NUMBER D2-14826

TITLE TECHNICAL FACILITY CRITERIA FOR THE MINUTEMAN LAUNCH FACILITIES - FRANCIS E. WARREN AFB, WYOMING (U)

The technical facility criteria document for the Minuteman Launch Facilities at Francis E. Warren AFB is issued as a supplement to the Wing III Launch Facility criteria presented in Boeing Document D2-13797. The complete Wing V Launch Facility criteria consists of the following:

02-14826
 5-3.1
 PAGE 12

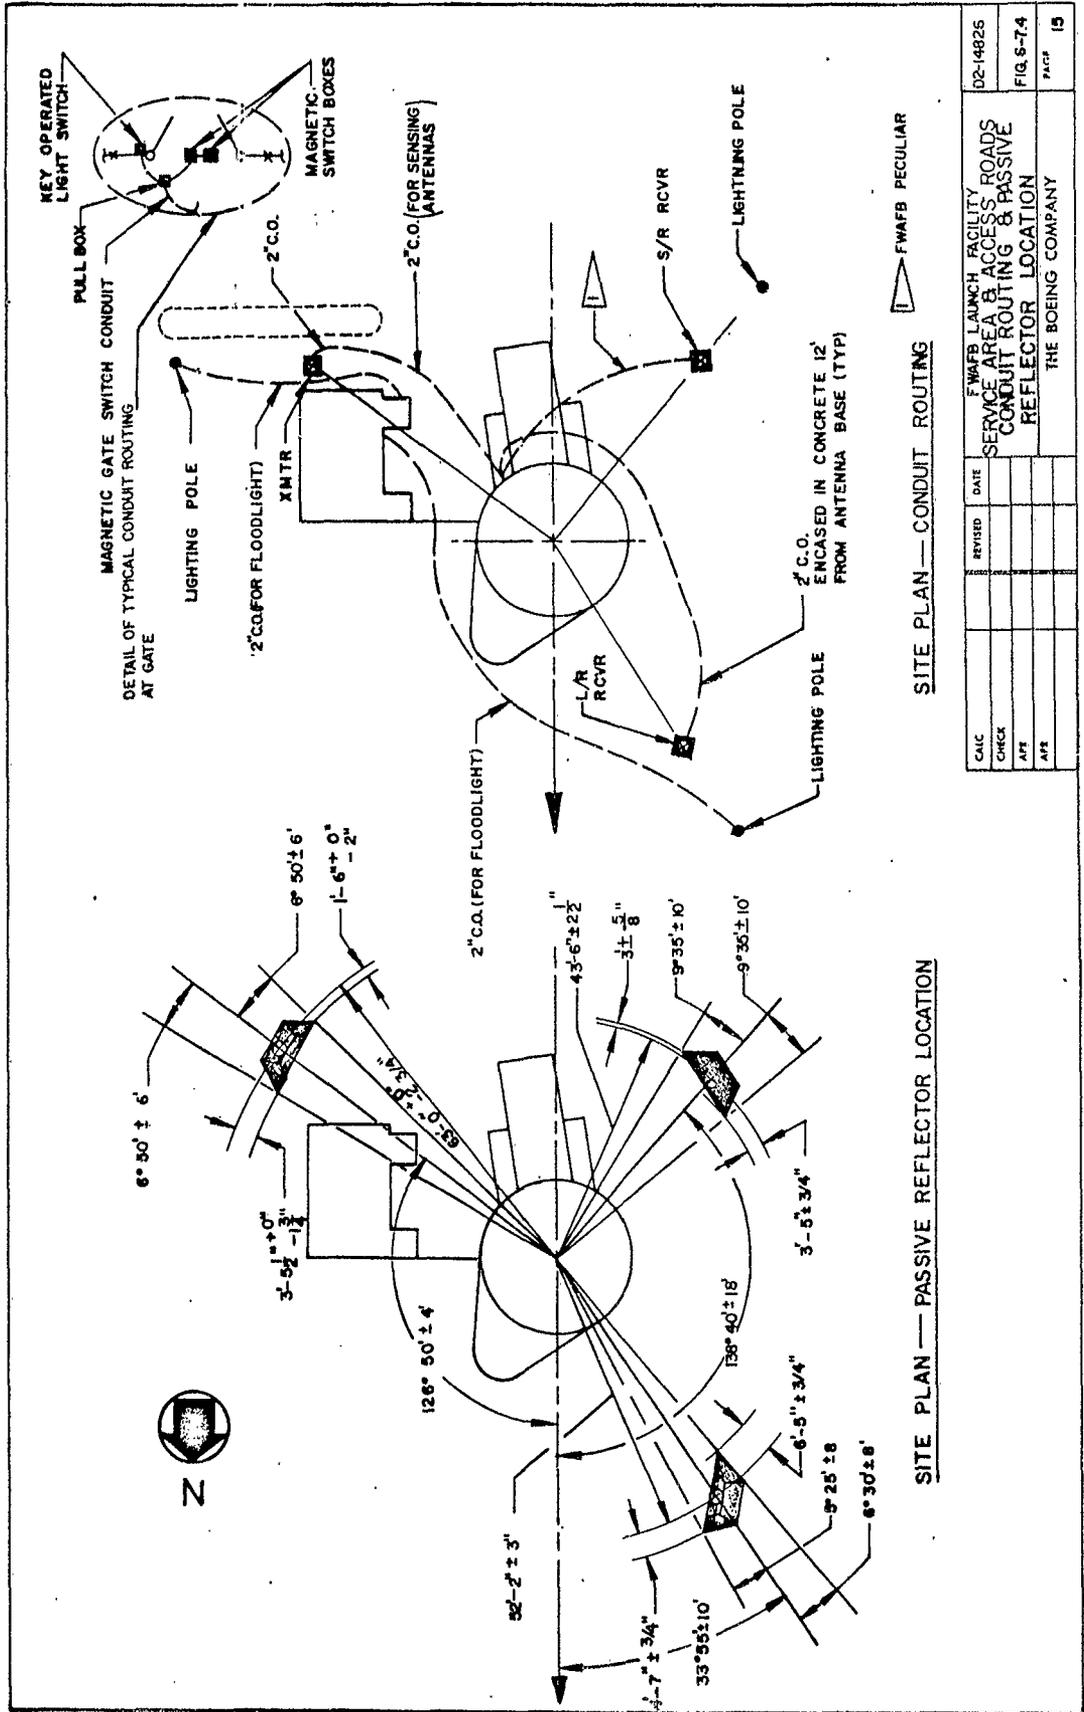
5.11.1 Figure 5-3.1 is revised to indicate the FWAFB peculiar layout of intra-site cabling and conduits between the Launcher and LSB.

D2-14926
 FIG. S-74
 PAGE 15

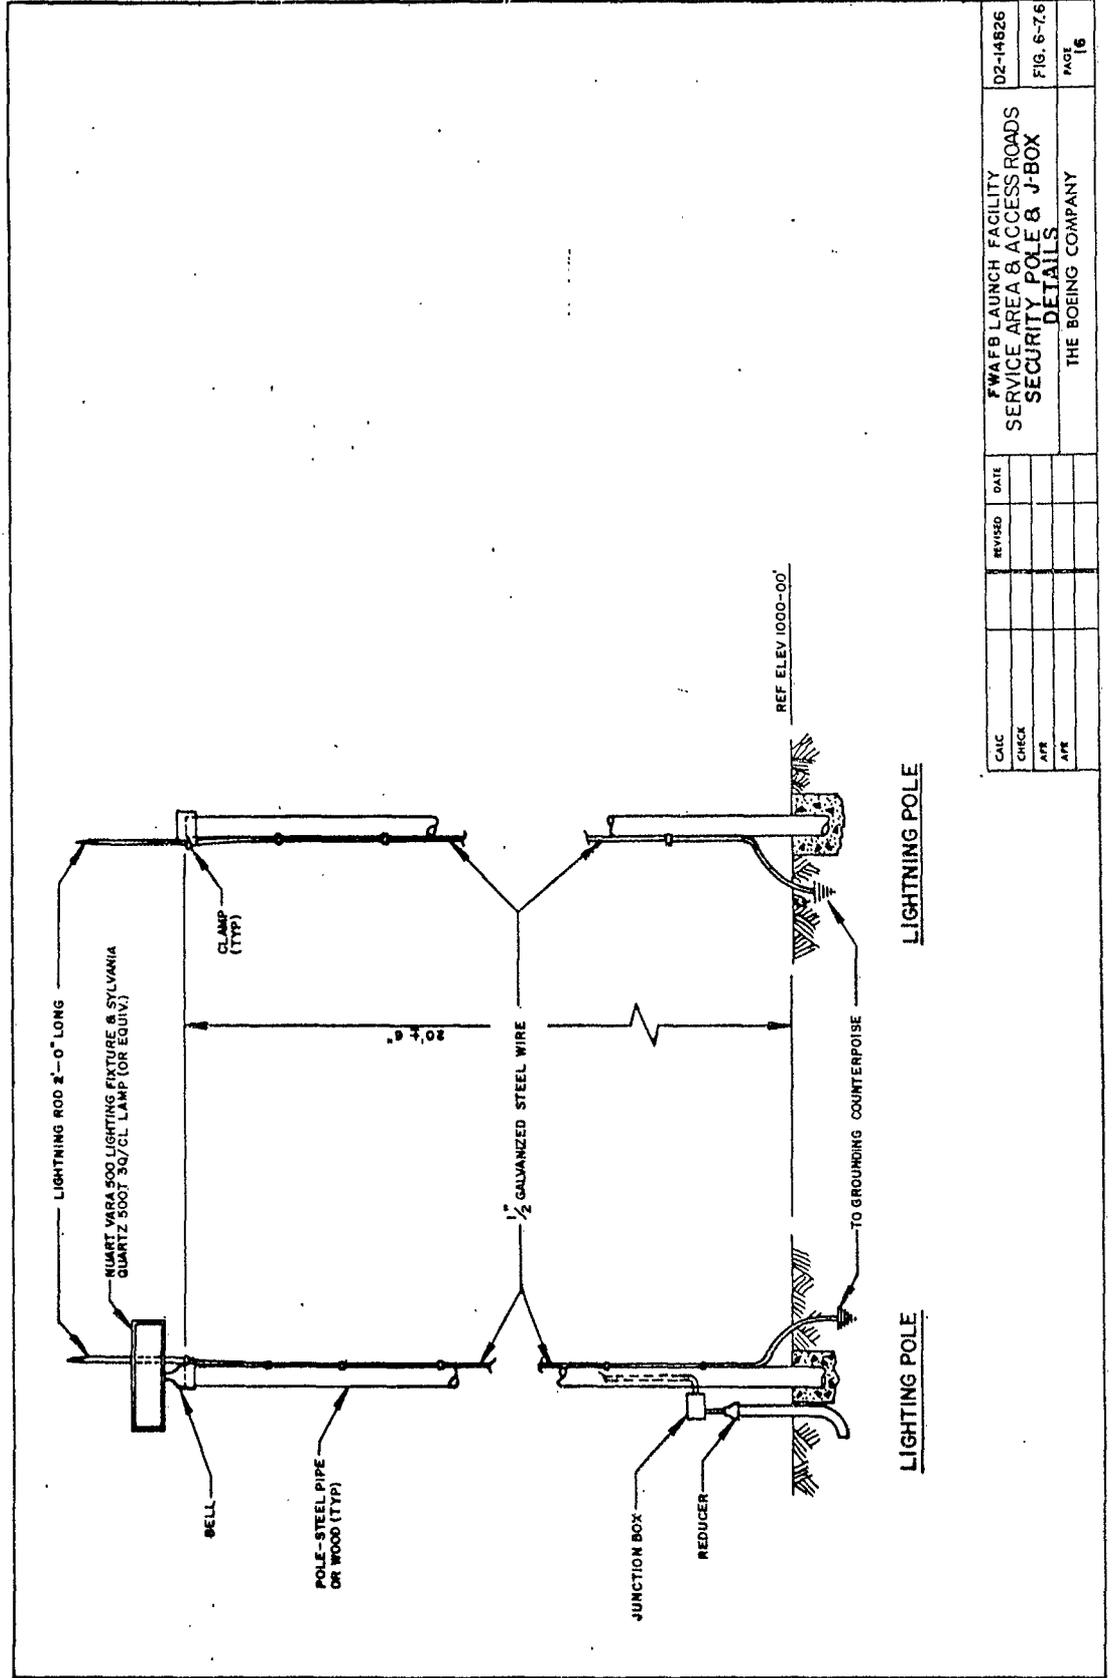
6.10.1 Figure 6-7.4 deletes Security J-Box located near XMTR antenna and also the 2nd c.o. extending between the Security J-Box and the S/R RCVR. A conduit is added between the Launcher and the S/R RCVR.

CAUC	REVISED	DATE	FWA/FB LAUNCH FACILITY LAUNCHER SUPPORT BUILDING ENVIRONMENTAL CONTROL EQUIPMENT THE BOEING COMPANY
CHCK			
APP			
APP			
			D2-14826
			FIG. 7-1
			PAGE 18

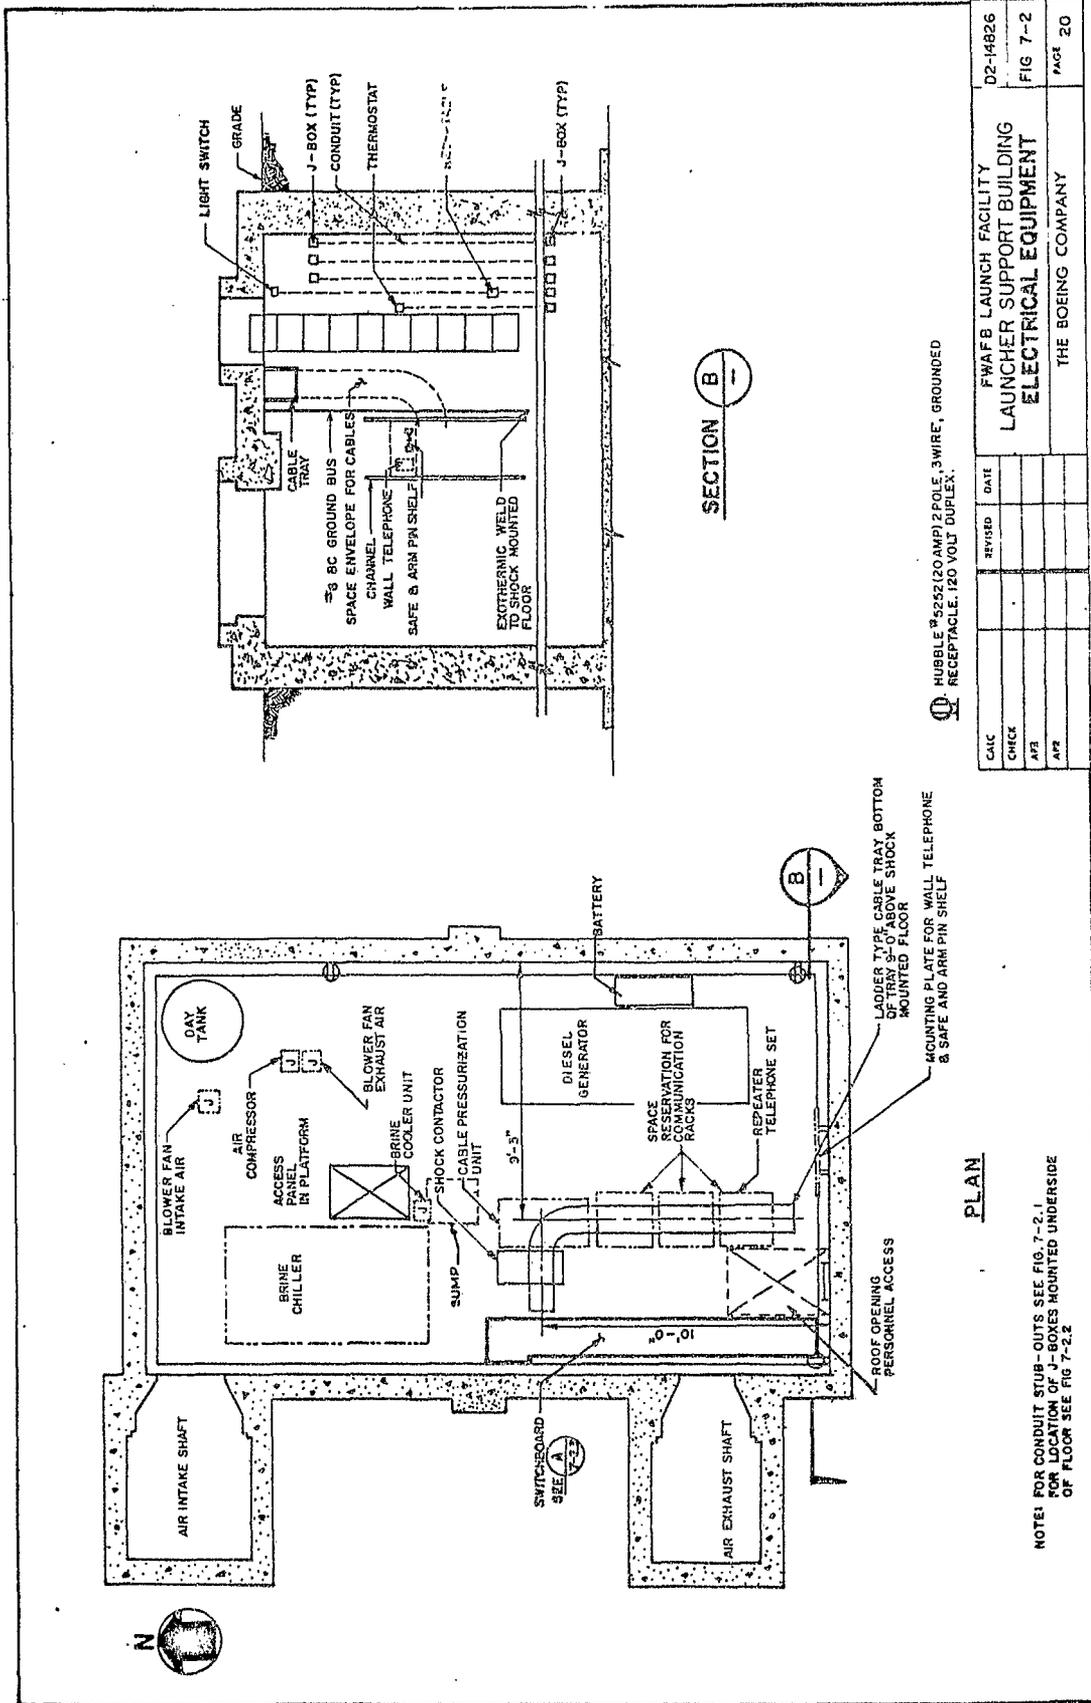
7.8.1 Figure 7-1 indicates the change in size of hydraulic lines from $\frac{1}{4}$ " to $\frac{1}{2}$ ", and relocates penetration of the 1" sump pump drain line.

CALC	REVISION	DATE	FWA/AFB LAUNCH FACILITY LAUNCHER SUPPORT BUILDING ELECTRICAL CONDUIT DETAILS THE BOEING COMPANY	D2-14826	
CHECK				FIG. 7-2.1	
APP				PAGE	21
APP

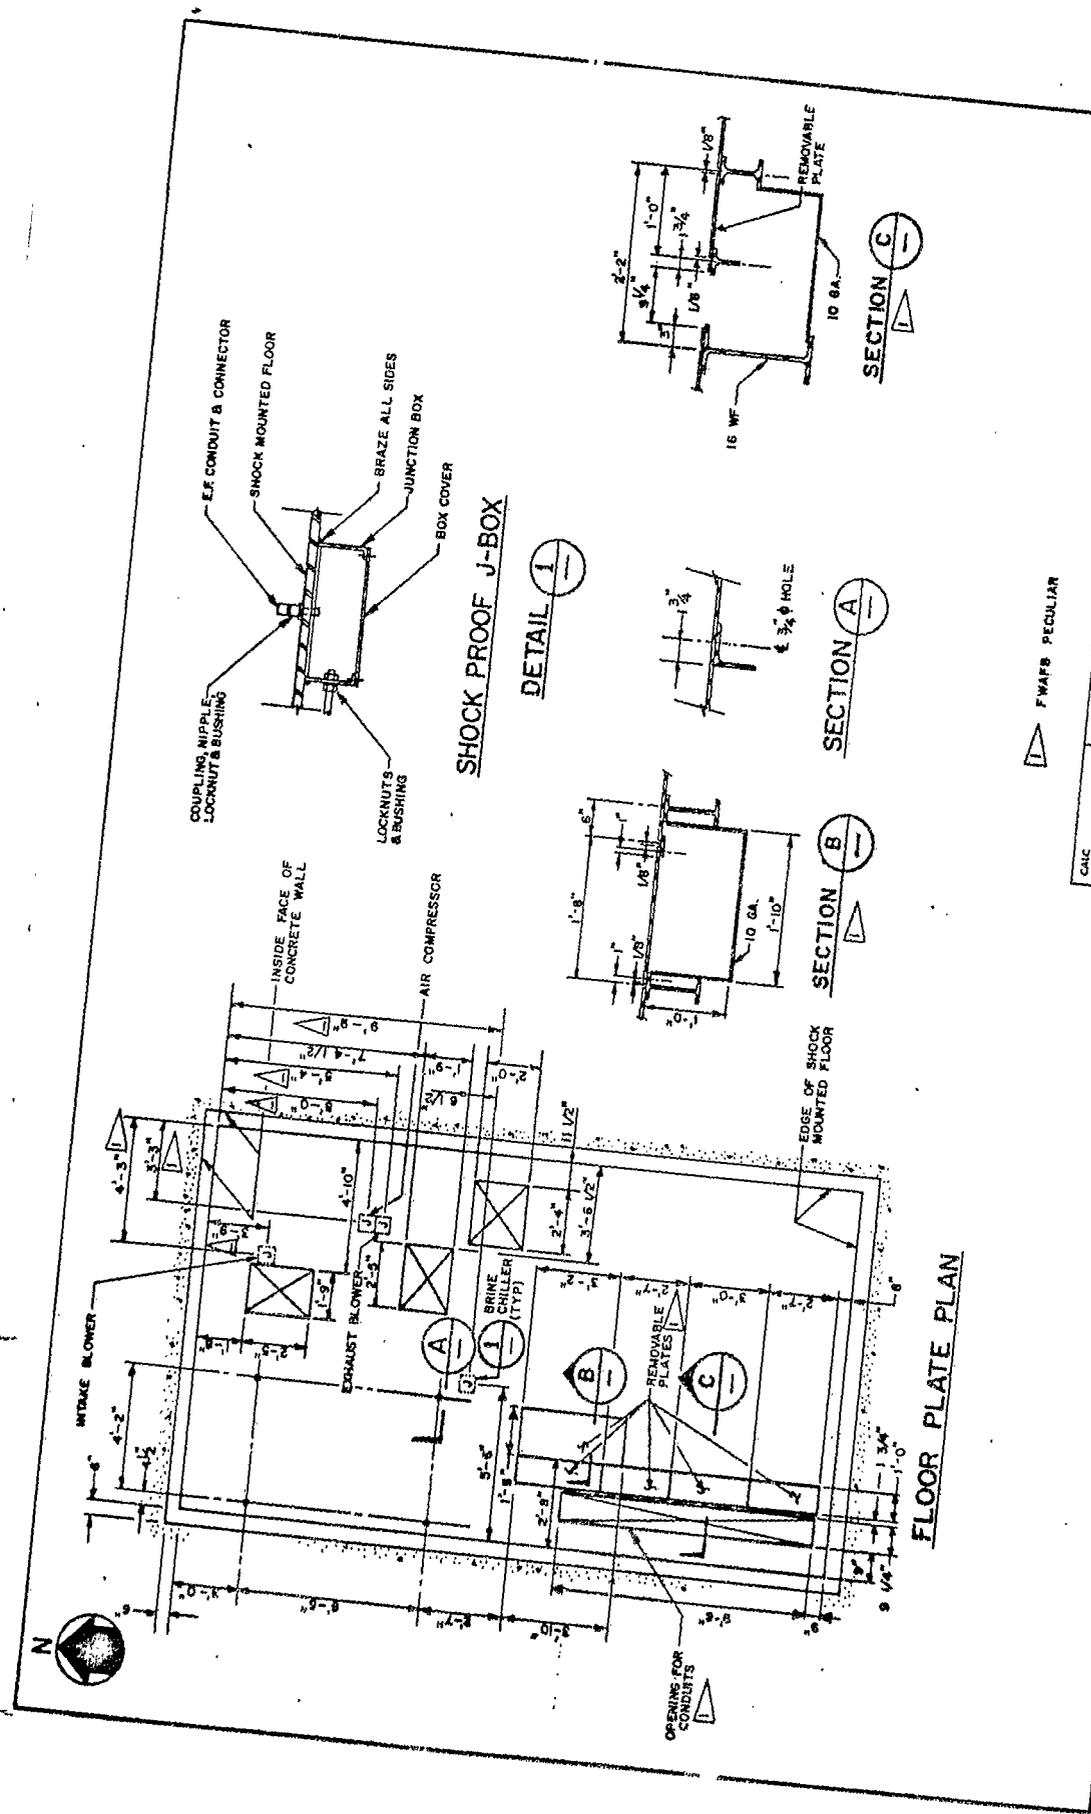
7.8.4 Figure 7-2.1 relocates the intrasite cable penetrations at the LSB exterior wall.

02-14826
 FIG. 7-2.2
 PAGE 22

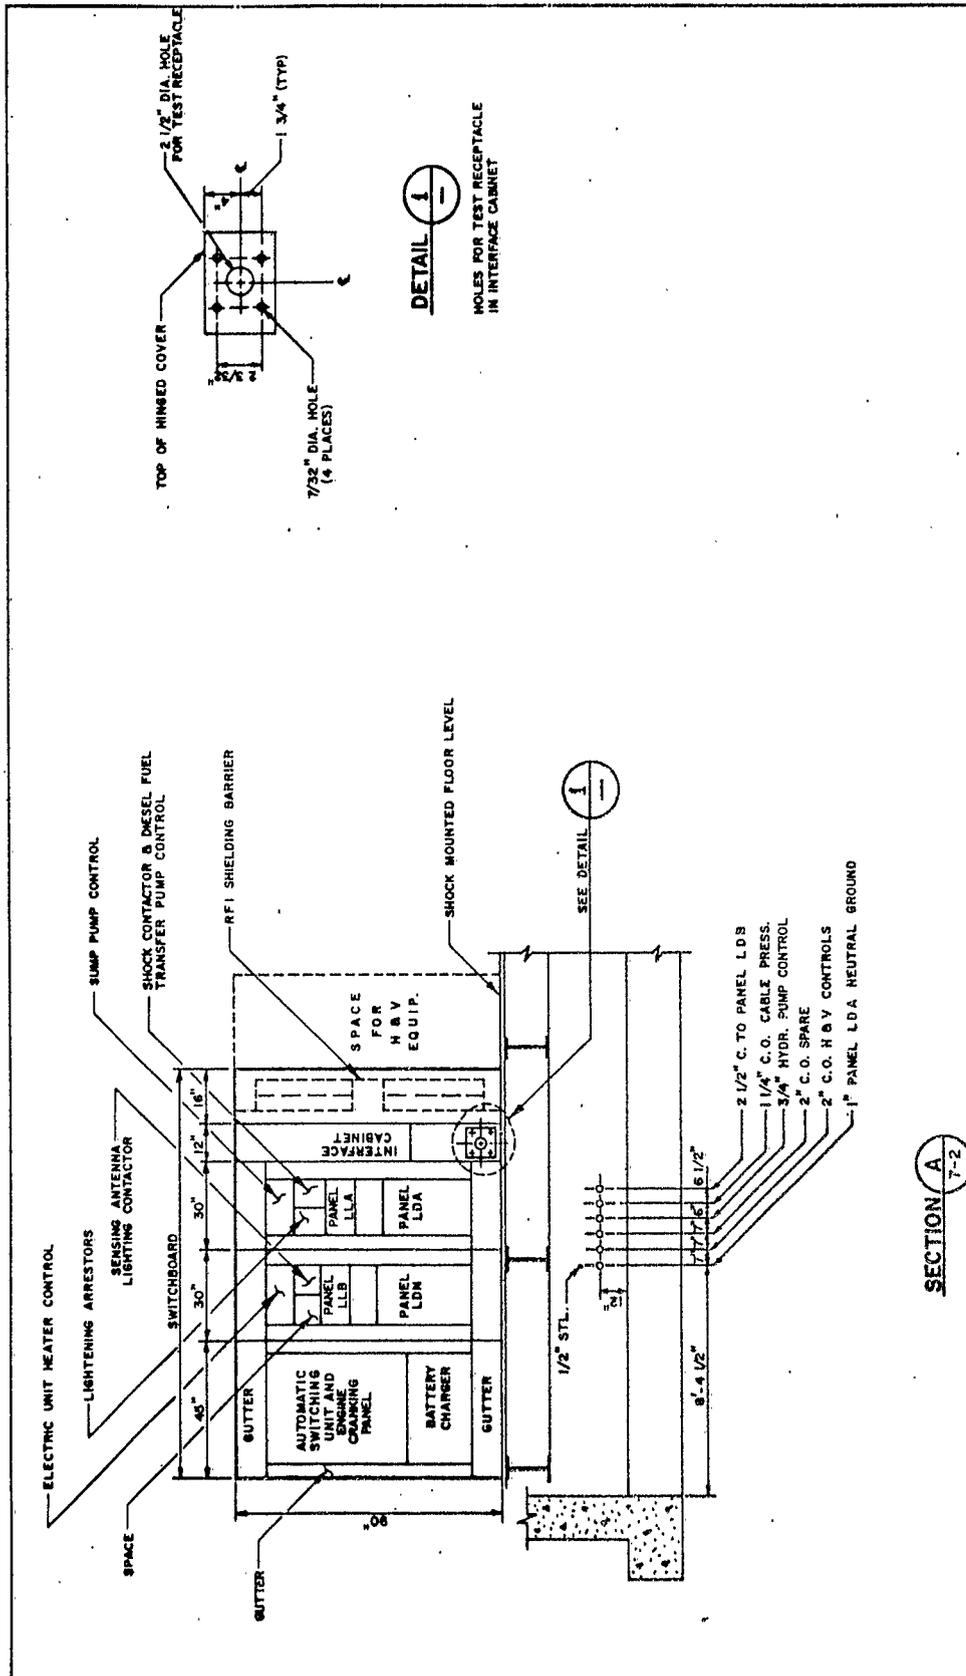
7.8.5 Figure 7-2.2 specifies the variations to the location of openings and J-boxes in the LSB shock mounted floor.

CALC	REVISED	DATE	F W A F B LAUNCH FACILITY	D2-14826
CHECK			LAUNCHER SUPPORT BUILDING	
APP			SWITCHBOARD ELEVATION	FIG. 7-2.3
APP			THE BOEING COMPANY	PAGE 23

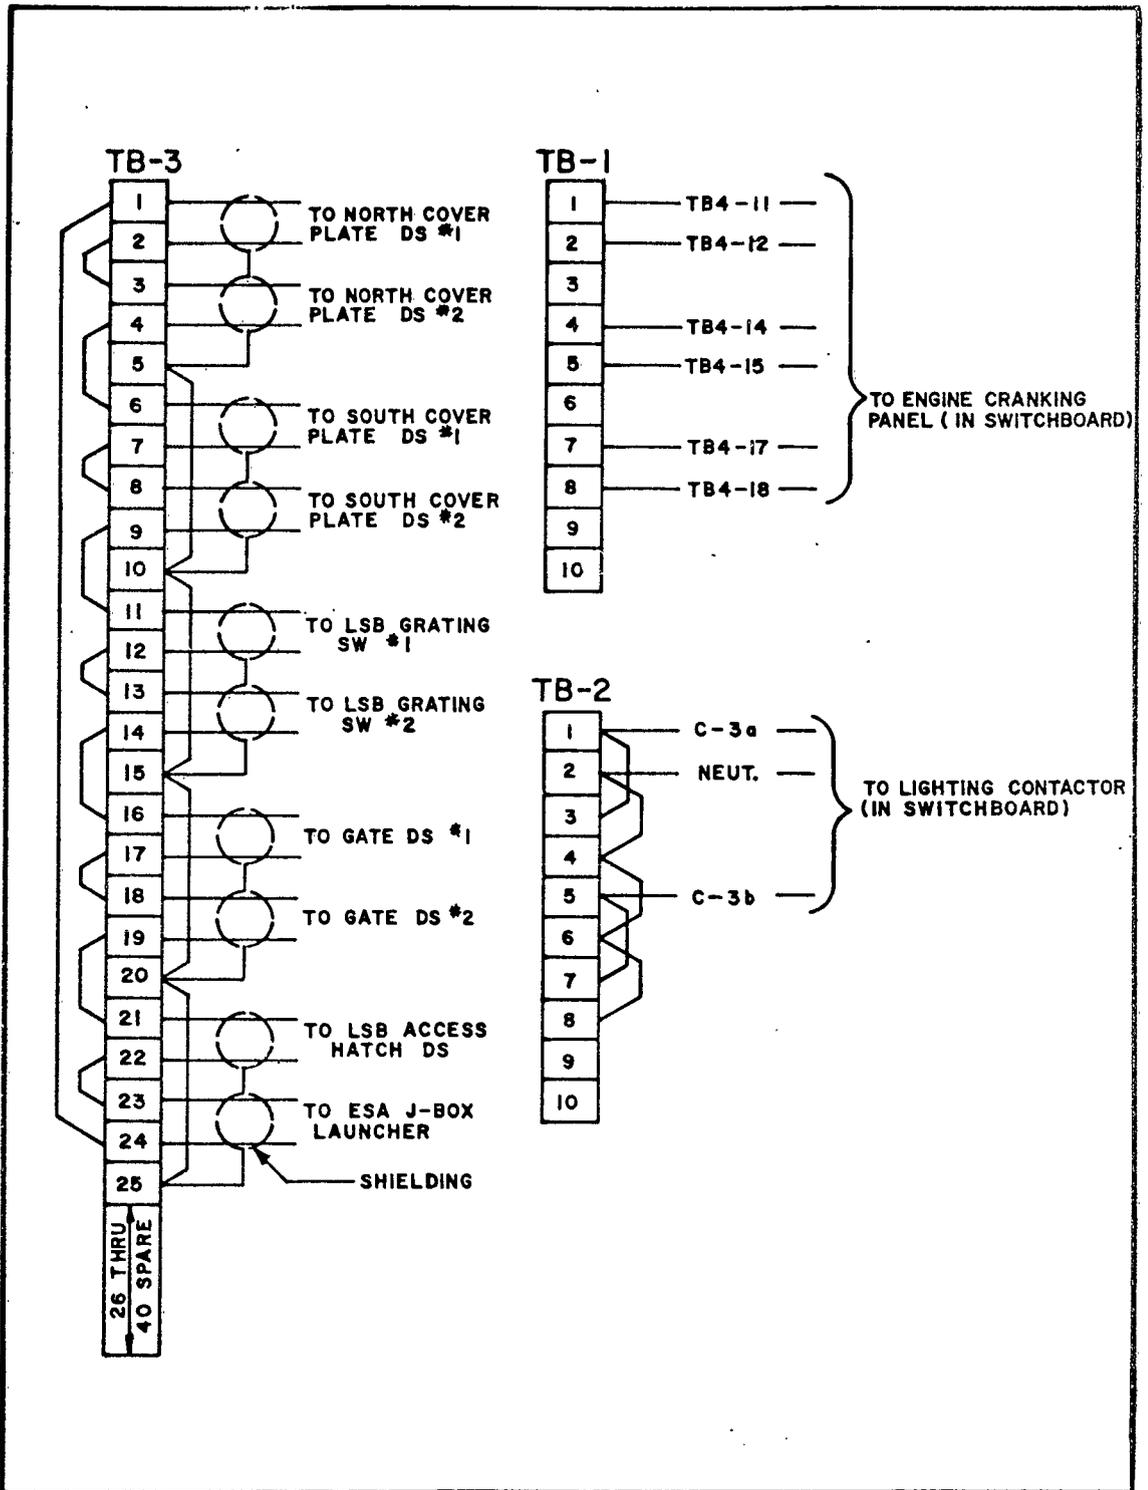
7.8.6 Figure 7-2.3 is added to show the switchboard panel elevation and necessary details.
